ISSUE: Certificate of Appropriateness for alterations

APPLICANT: Landini Restaurant, Inc. Noe Landini

LOCATION: Old and Historic Alexandria District
115 King Street

BAR APPLICATION EXTERIOR DUCTWORK V2
May 10, 2023

PROPOSED REAR ELEVATION 113 + 115 FAYETTE ALLEY REV

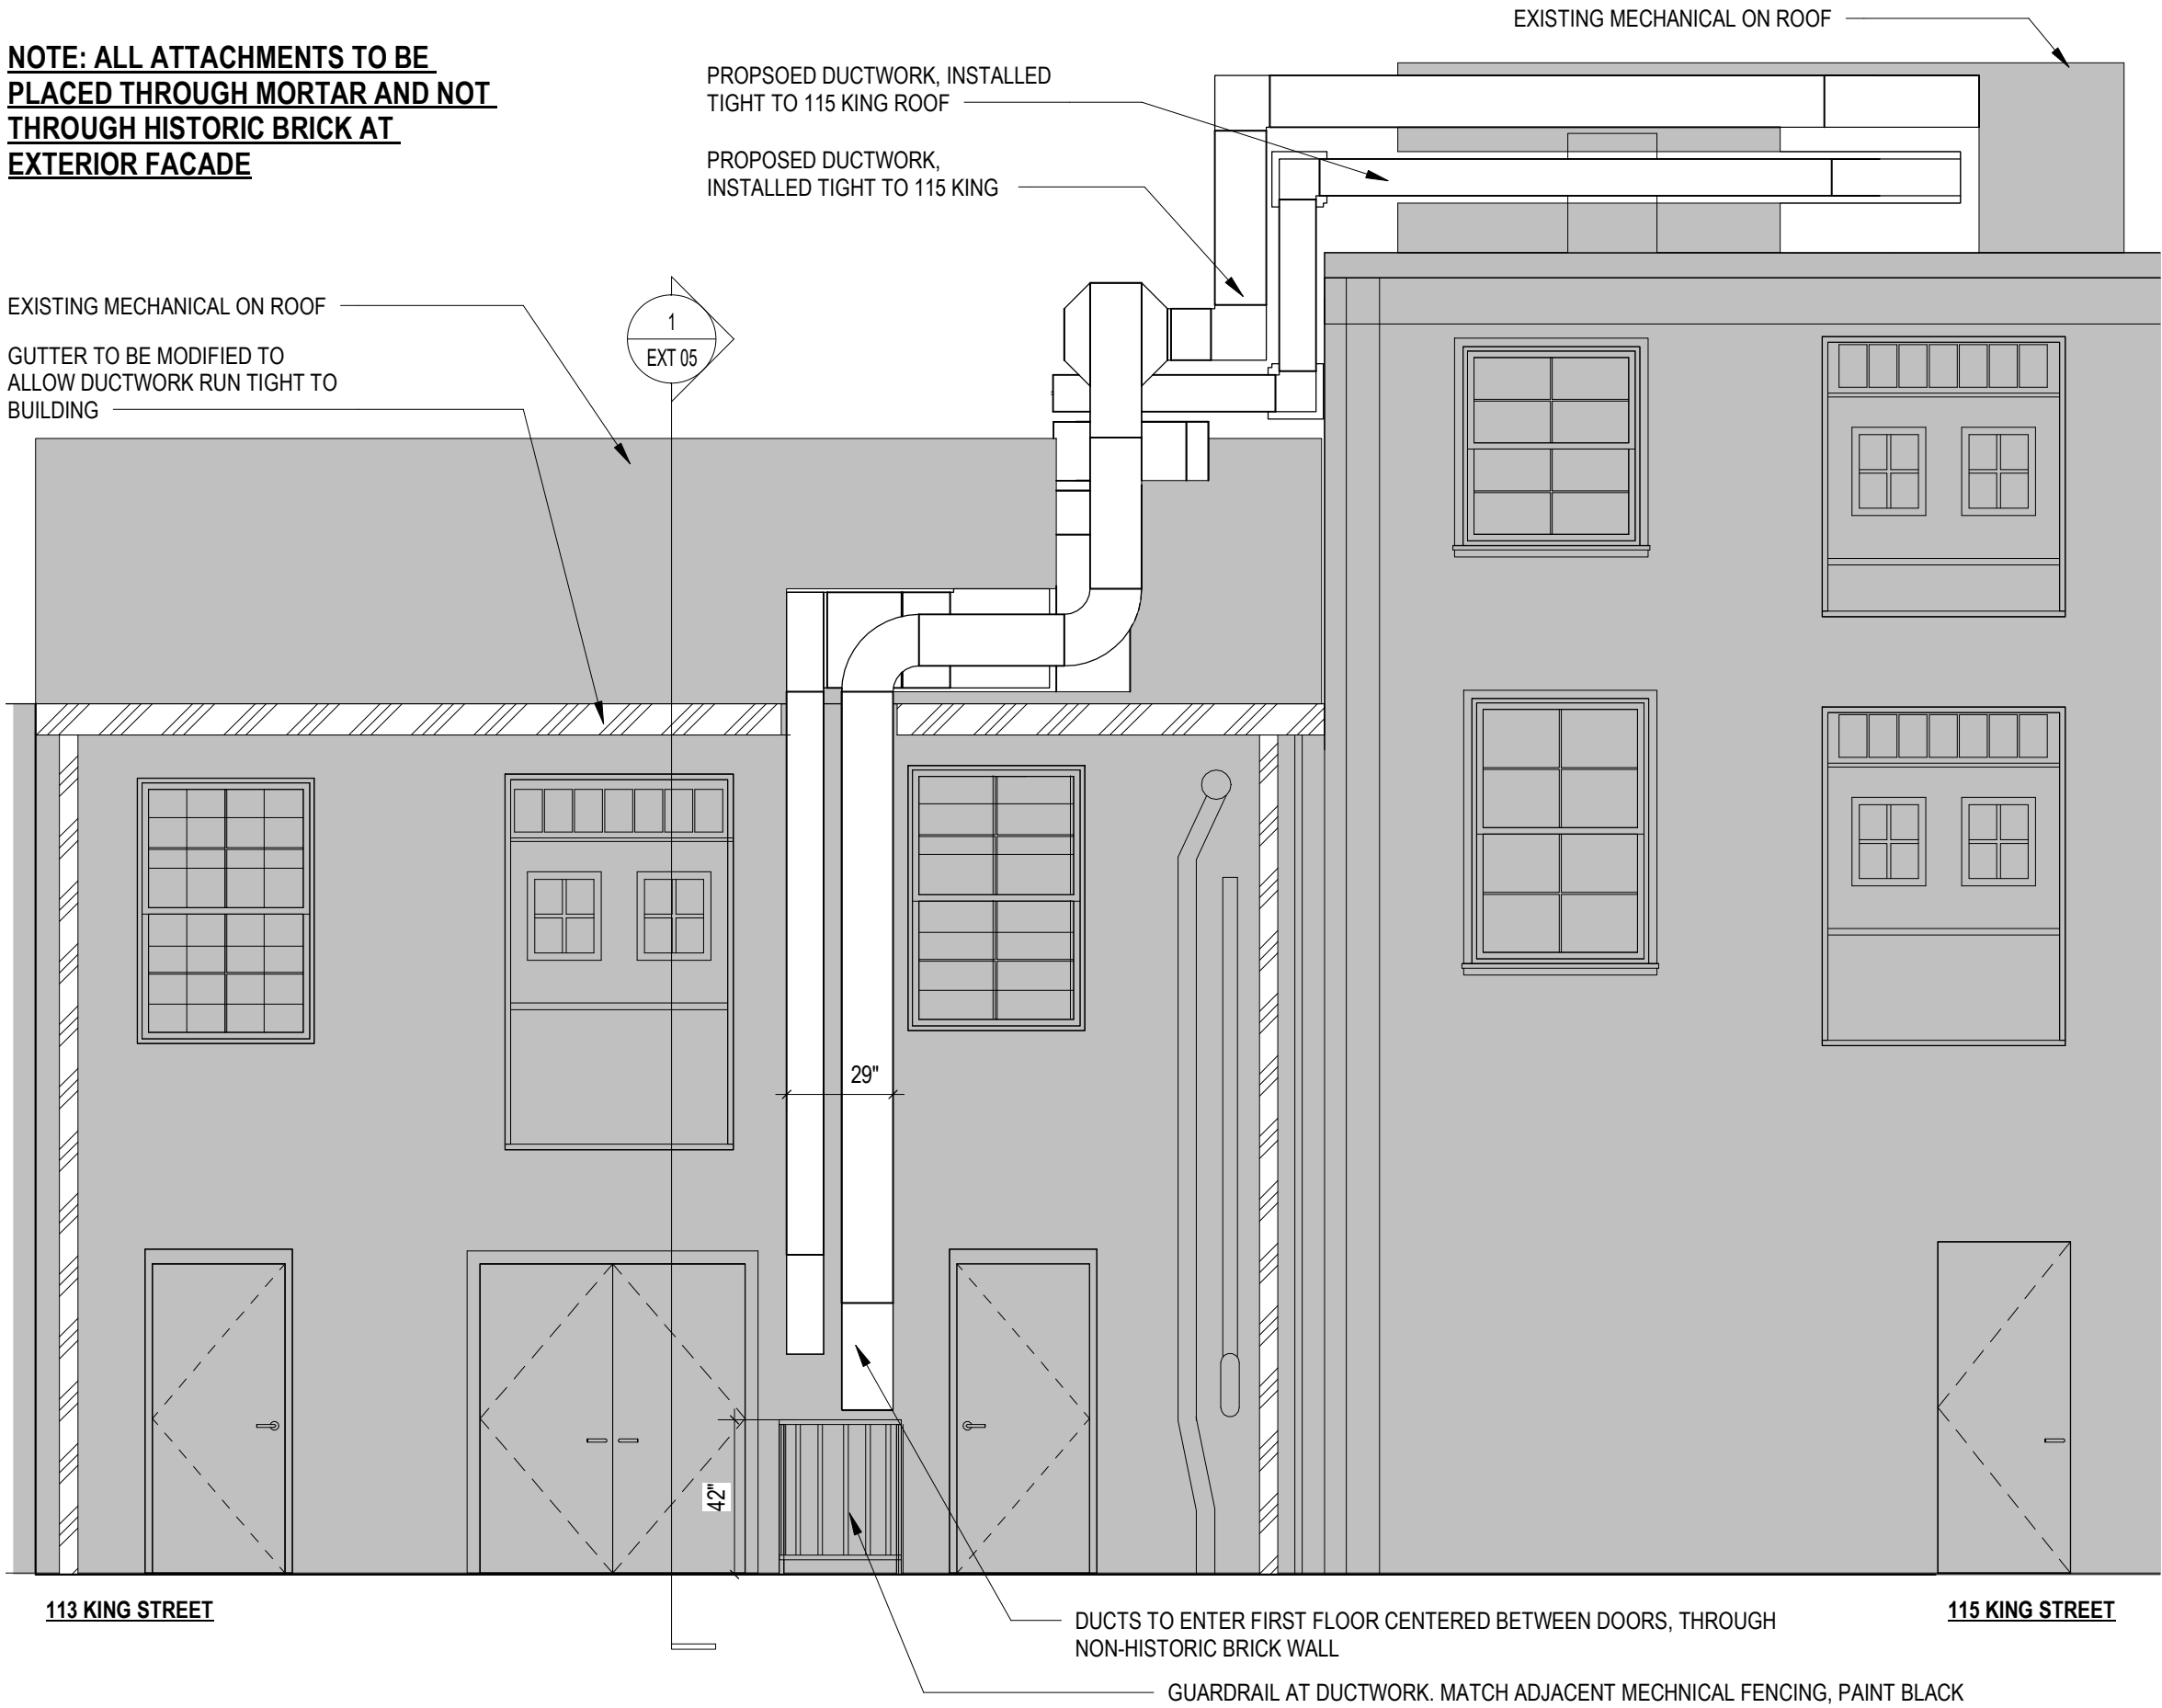
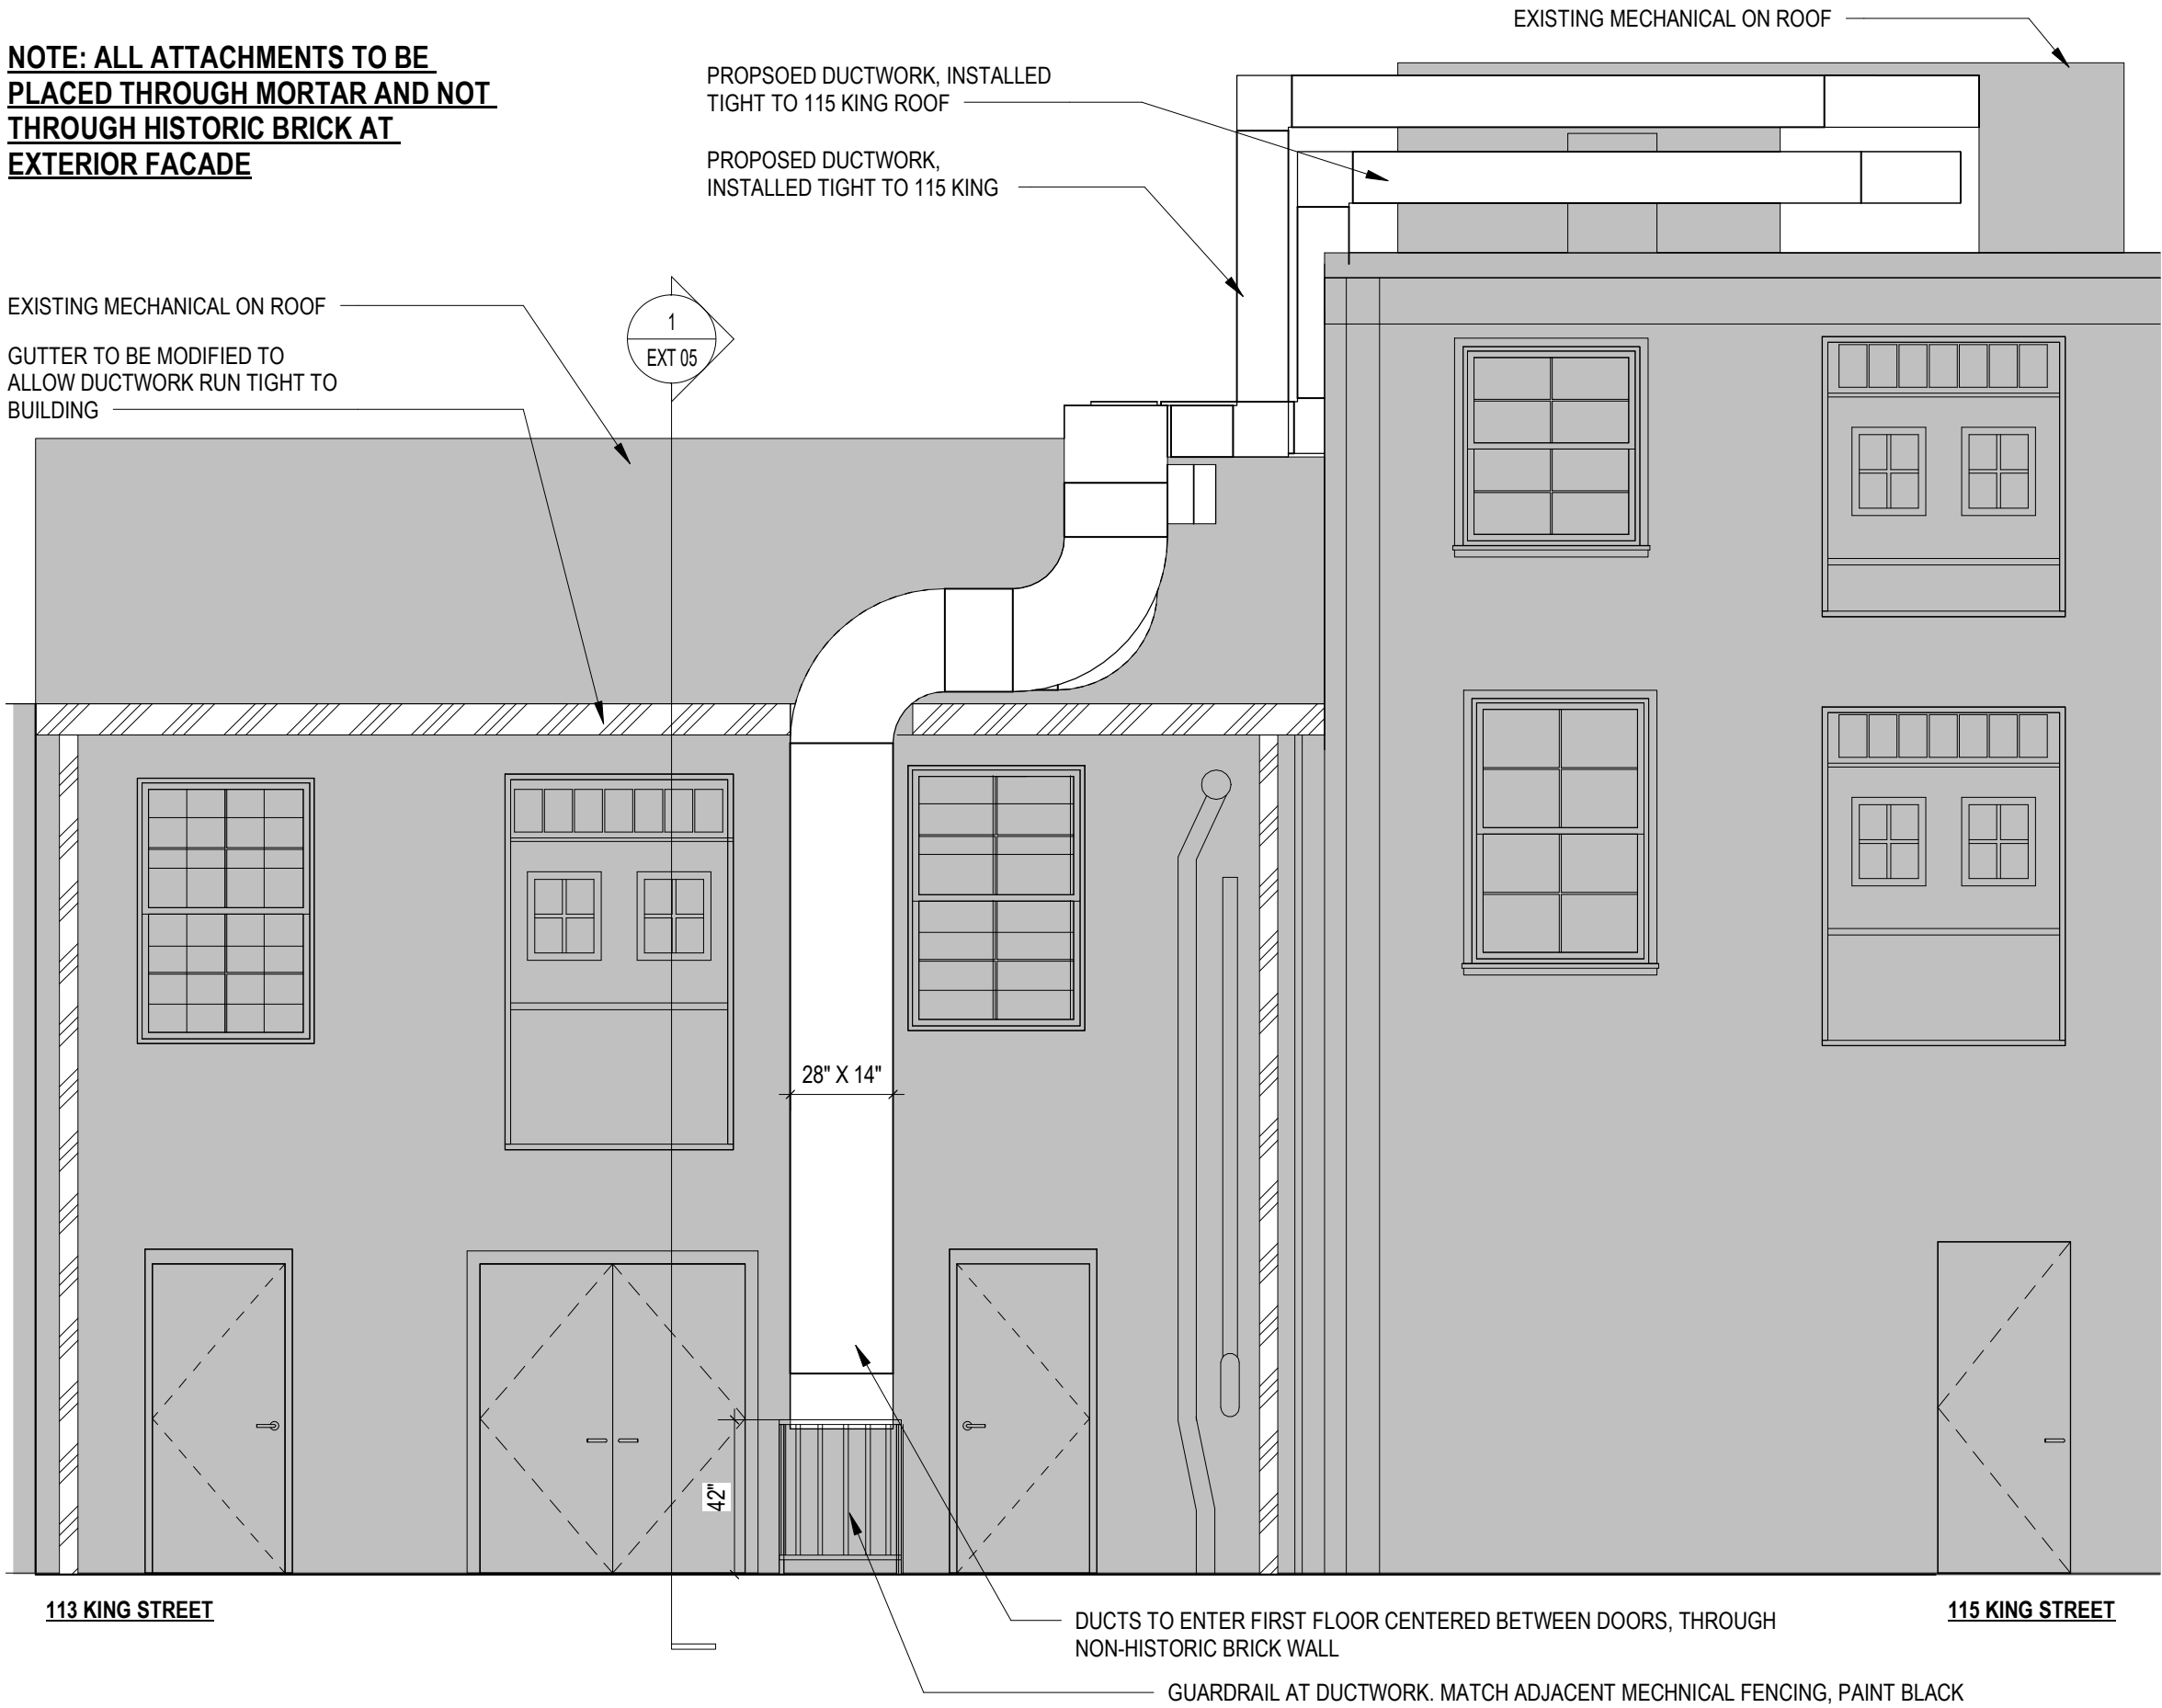
REVISED PER 5/4
HEARING COMMENTS

** NOTE: REQUIRED BRICK INFILL IN THIS OPTION WILL BE CLEARLY VISIBLE IN ELEVATION. TWO SETS OF DUCT SUPPORTS REQUIRED, TWO SETS OF STRAPPING AND CONNECTIONS POTENTIAL TO DRAW MORE ATTENTION TO THE DUCTWORK.

**** NOTE: RECOORDINATION WITH MEP PROMPTED LASER SCAN REVIEW OF EXTERIOR. RIGHT WINDOW AND DOOR ON 113 REQUIRED TO SHIFT +/-8" TO LEFT. THIS ELEVATION HAS BEEN UPDATED FROM 5/4 PRESENTATION TO REFLECT LASER VERIFIED AS BUILT CONDITIONS.**
